January 31, 2023

ADDENDUM NO. 3

**FAITHON P. LUCAS BOULEVARD
PAVING AND DRAINAGE RECONSTRUCTION
(MCKENZIE ROAD TO E. CARTWRIGHT ROAD)
RFP NO. 2023-029**

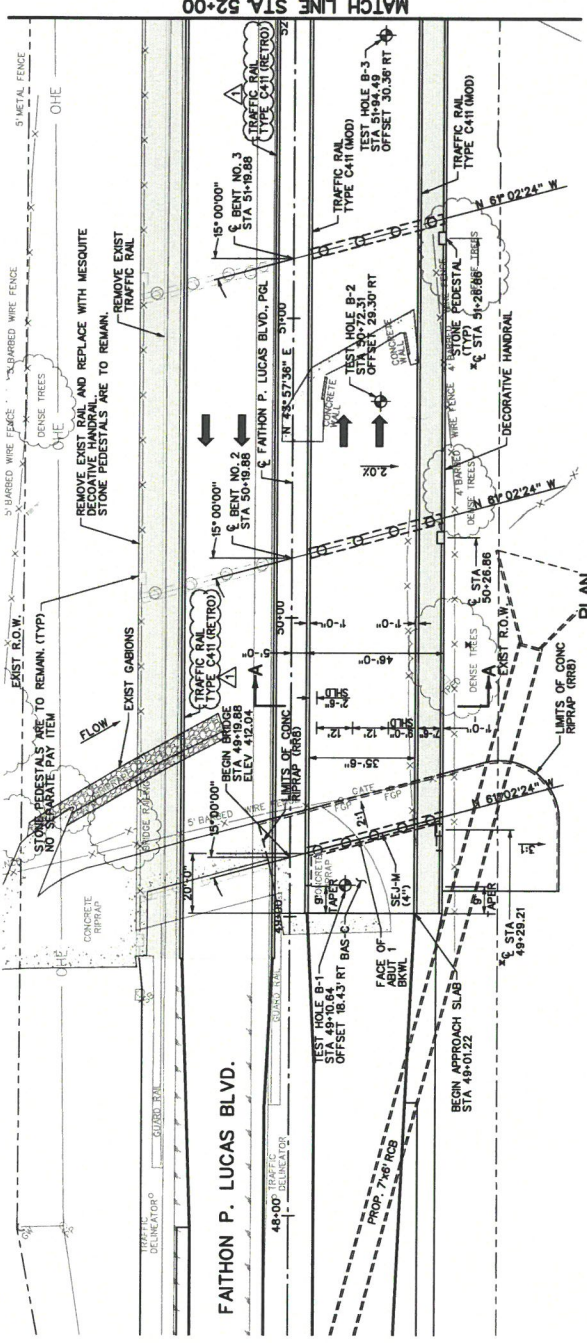
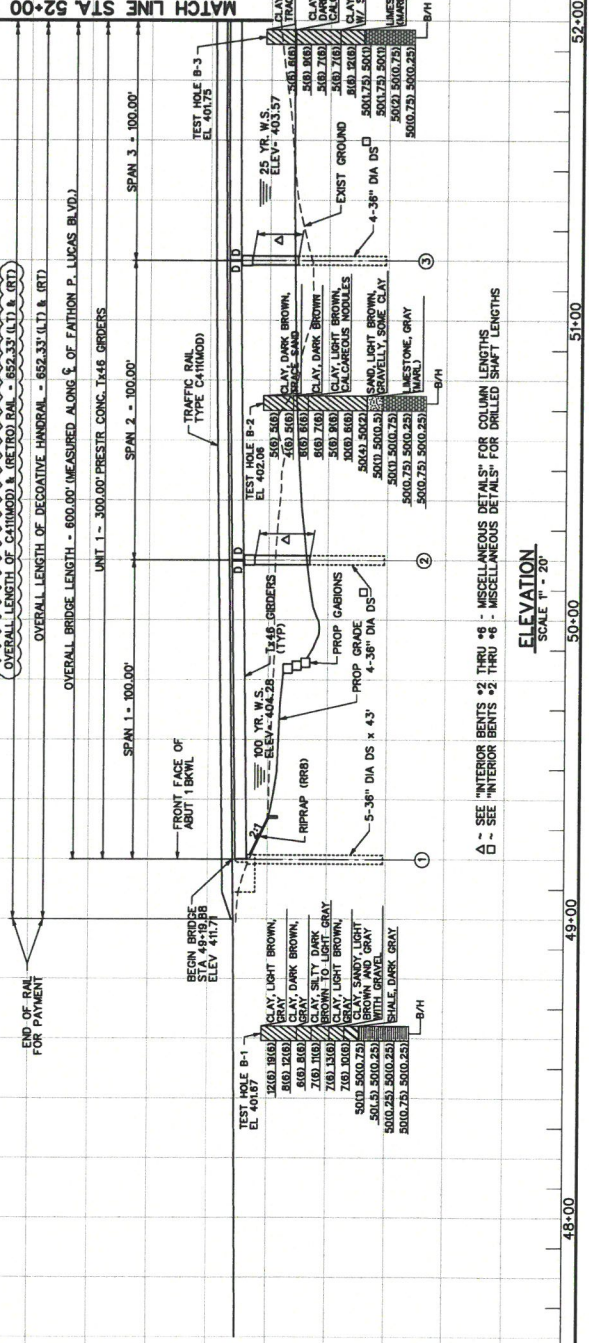
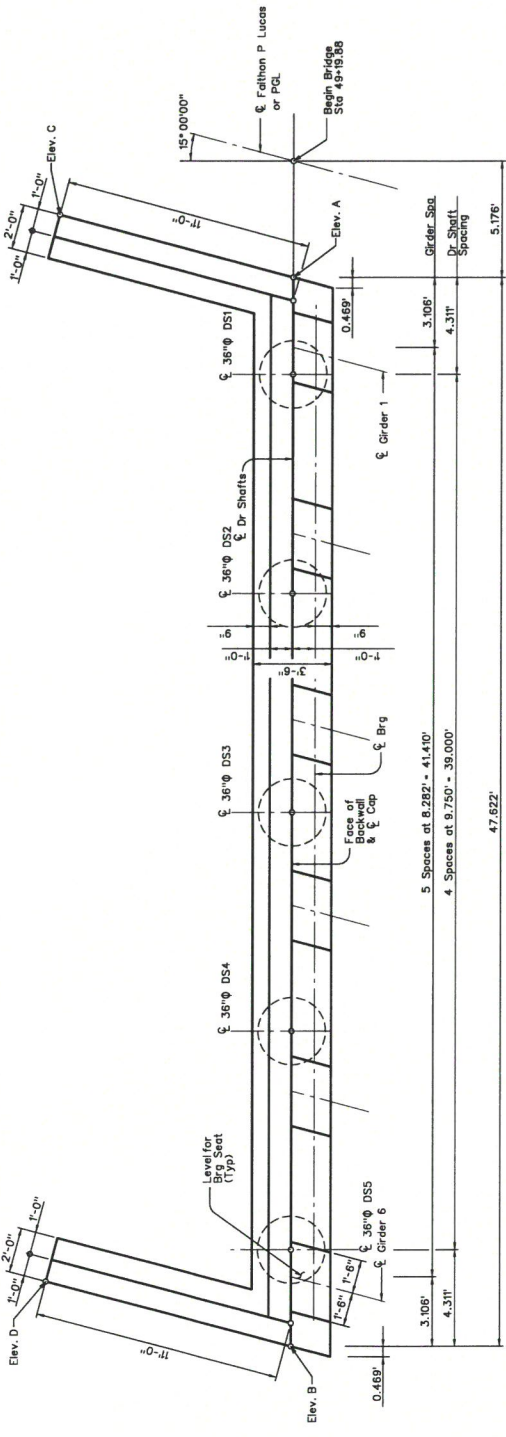
REV. NO.	DATE	REVISIONS	BY	TFT
1	1-27-23	REVISED CALLOUT

APM APM & Associates, Inc.
 CITY CONTRACT NO. 2022-065
 FAITHON P. LUCAS BLVD.
 FROM MCKENZIE RD. TO CARTWRIGHT RD.
 ABUTMENT #1

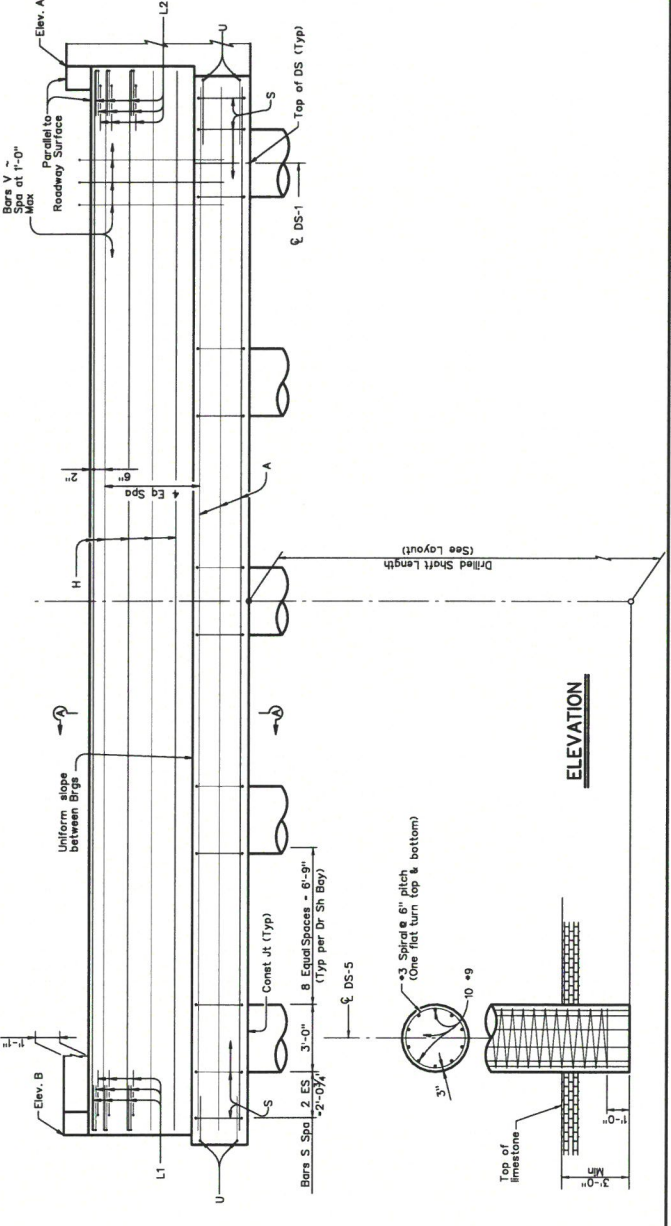
REV. NO.	DATE	BY	REVISION
1	1-27-23	TFT	REVISED GENERAL NOTE

REFERENCES
 ENGINEERING DIV. WATER MAP SHEET NO. 58 & 59
 ENGINEERING DIV. WATER MAP SHEET NO. 58 & 59
 CITY CONTRACT NO. 2022-085
 FROM MCKENZIE RD. TO CARTWRIGHT RD. ABUTMENT #7
 CITY OF MESQUITE, TEXAS
 DRAWN DATE RECORD DWG INDEX NO. SHEET
 APW 2023 2023-085-24 134 OF 252

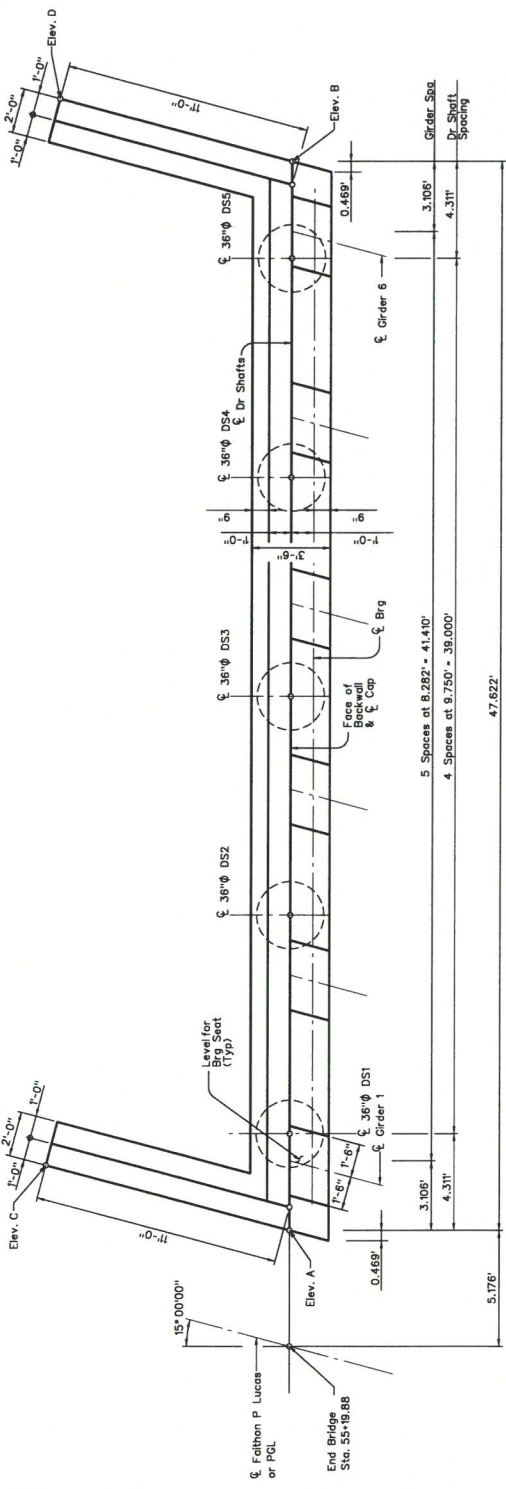
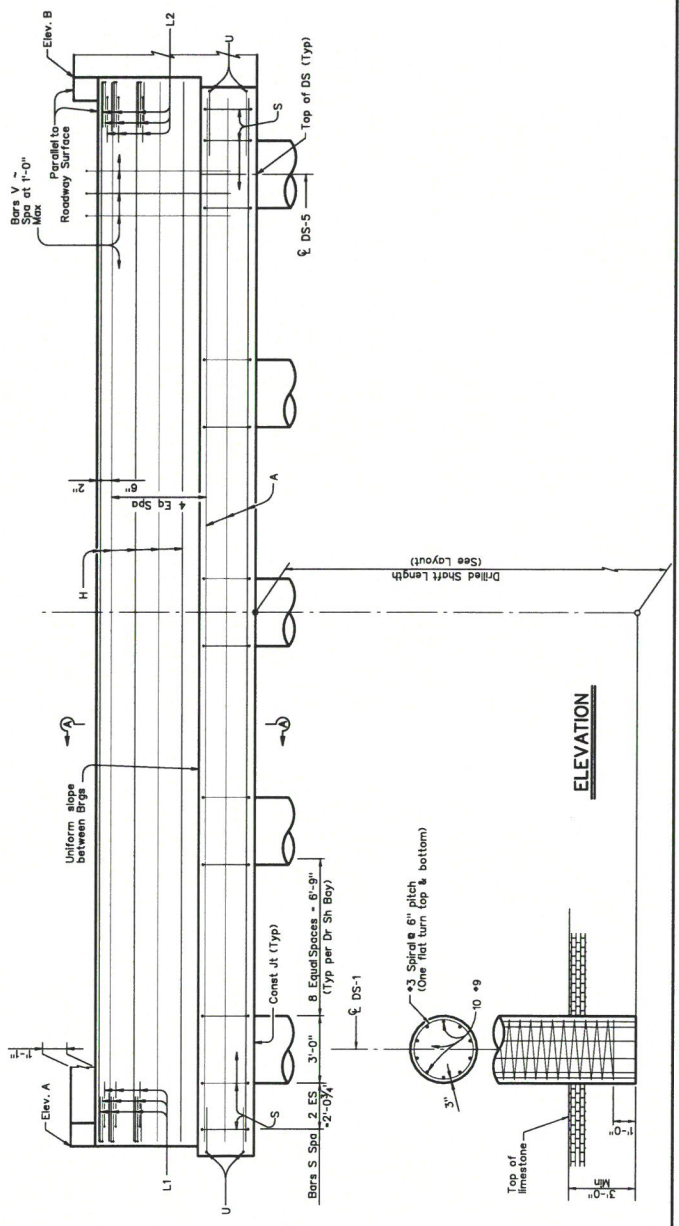
REV. NO.	DATE	DESCRIPTION	BY
1	1-27-23	REVISED GENERAL NOTE	TFT
2			TFT

CITY CONTRACT NO. 2020-095
FAYTHON P. LUCAS BLVD.
FROM MCKENZIE RD. TO CARTWRIGHT RD.
INTERIOR BENTS #2 THRU #6

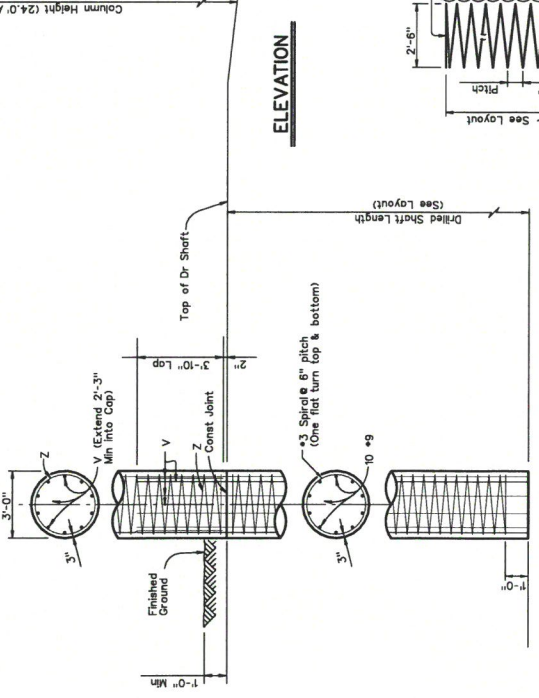
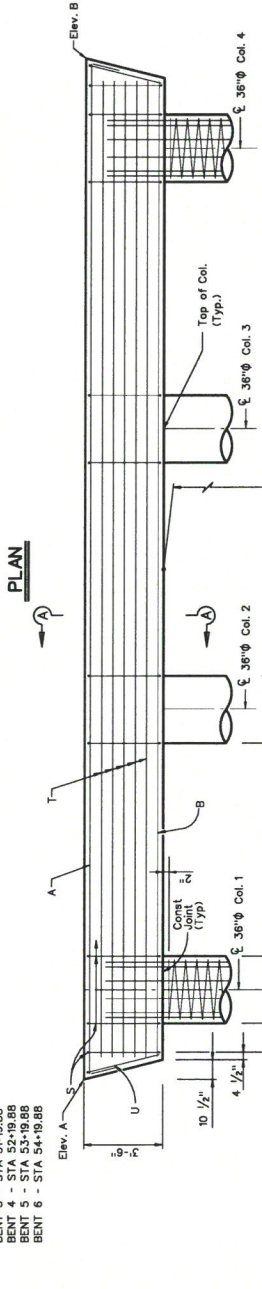
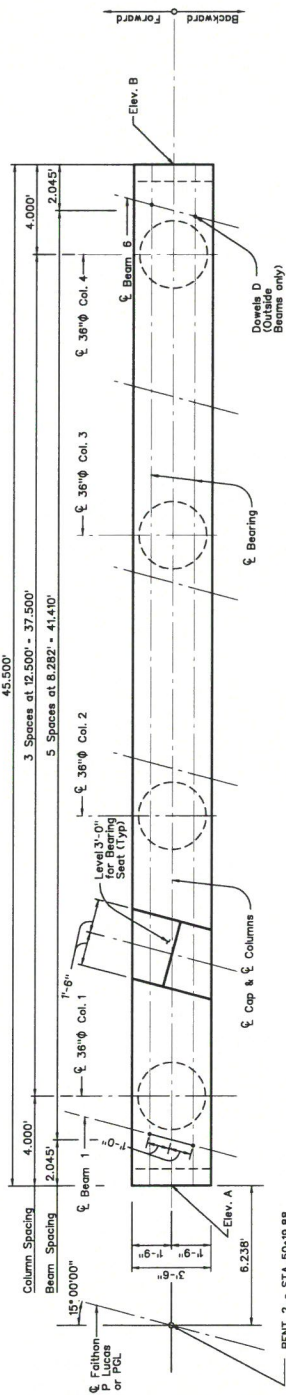
REV. NO.	DATE	DESCRIPTION	BY
1	1-27-23	REV GENERAL NOTE & CALLOUT	TFT

ENGINEERING ON WATER MAP SHEET NO. 58 & 59
 ENGINEERING ON WATER MAP SHEET NO. 58 & 59
 1/27/23
APM APM & Associates, Inc. 1000 West Loop South, Suite 200, Houston, Texas 77027
 CITY CONTRACT NO. 2020-085
 FAITHON P. LUCAS BLVD.
 FROM MCKENZIE RD. TO CARTWRIGHT RD.
 GIRDER LAYOUT

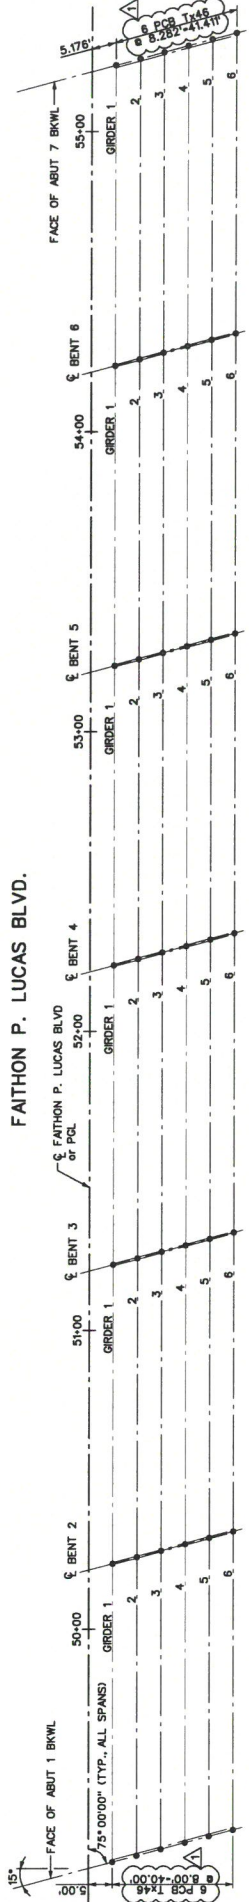
REV. NO.	DATE	DESCRIPTION	BY
1	1-27-23	REVISED CALLOUT TO T446	TFT

FROM MCKENZIE RD. TO CARTWRIGHT RD.
 SLAB DETAILS - UNIT 1 & 2

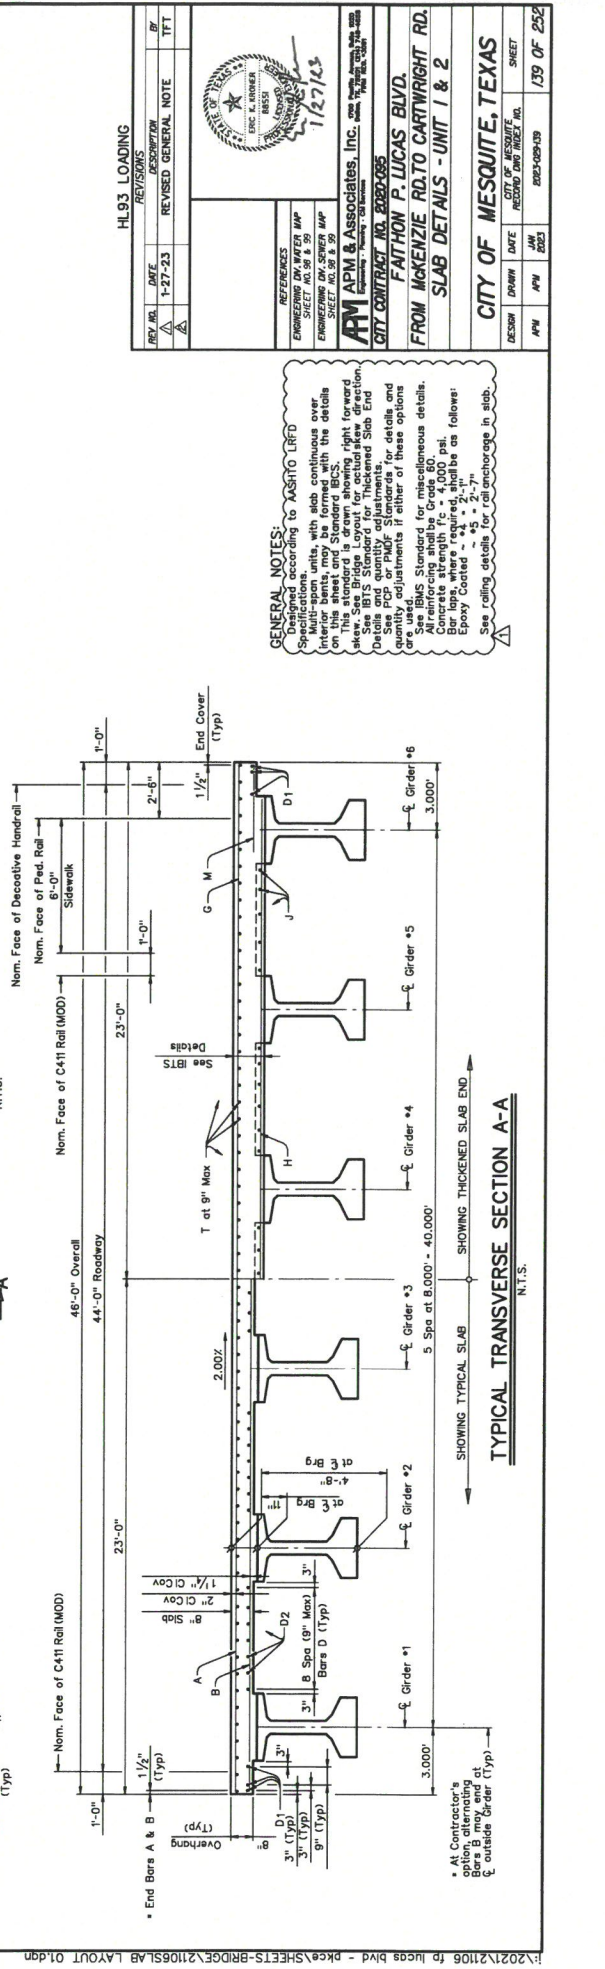
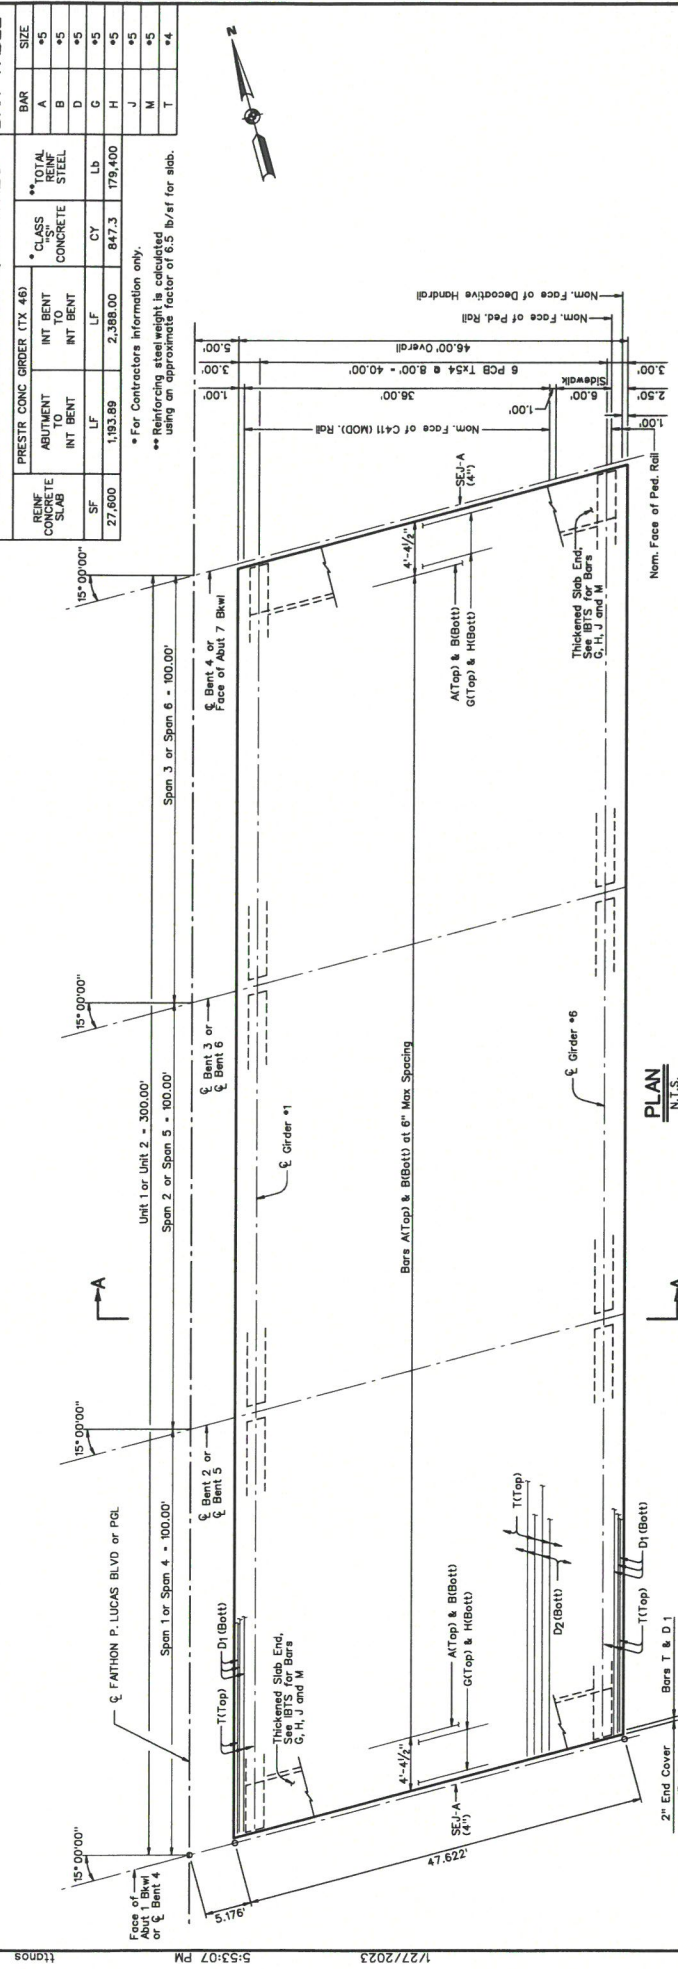
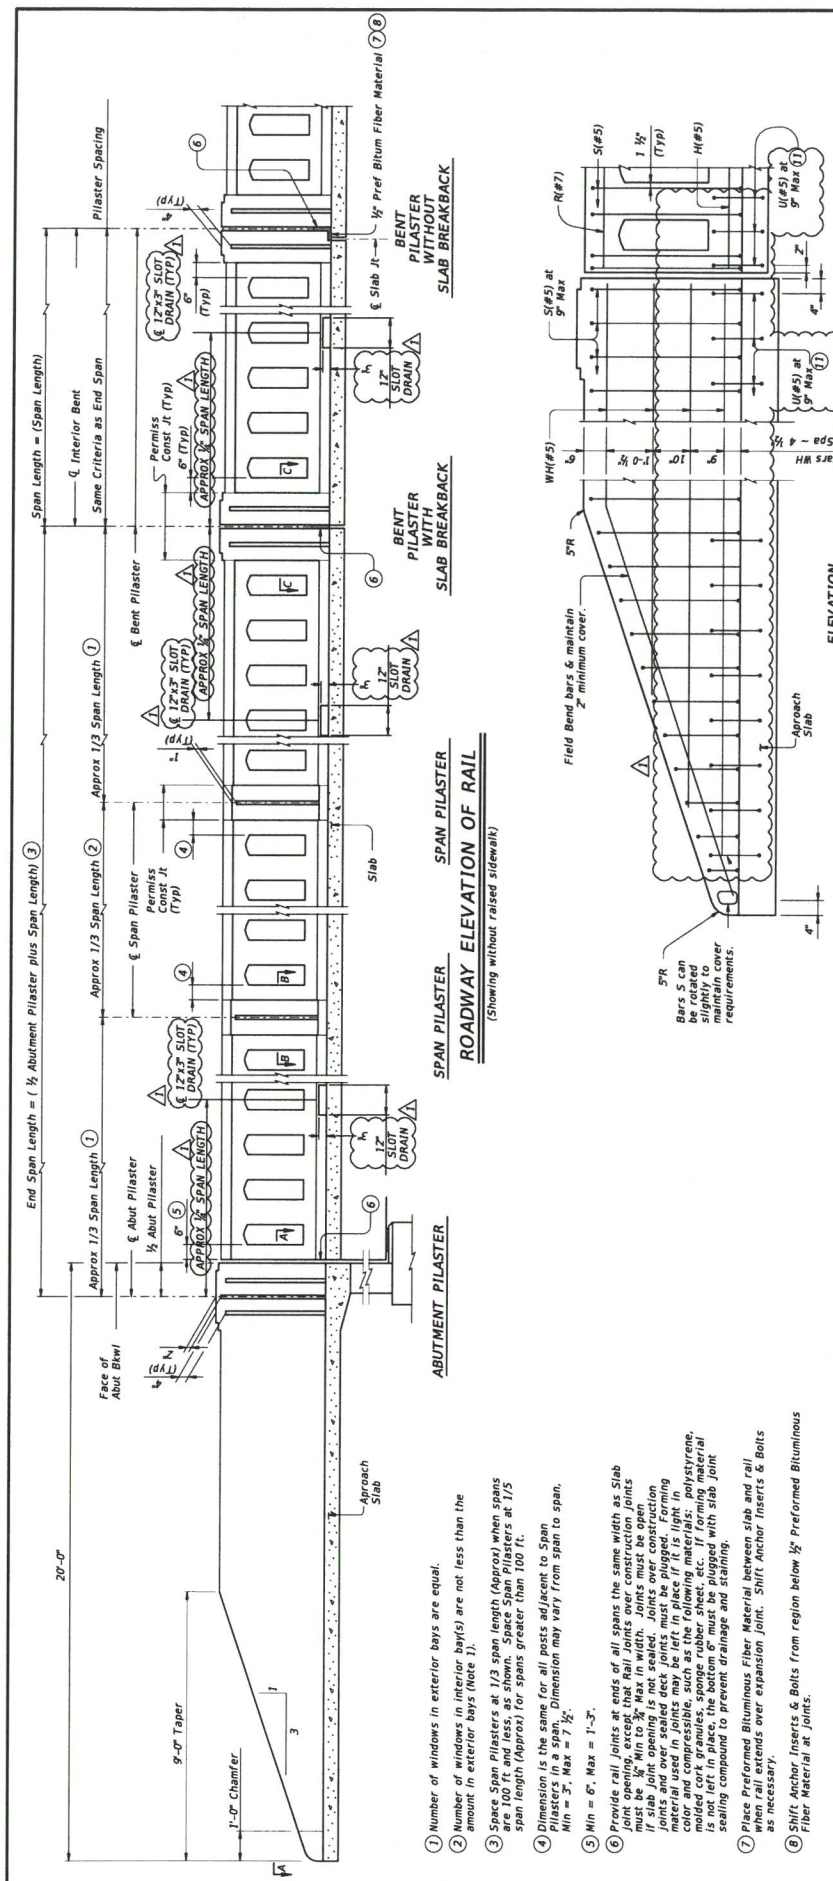
REV. NO.	DATE	DESCRIPTION	BY
1-27-23		REVISED GENERAL NOTE	TFT
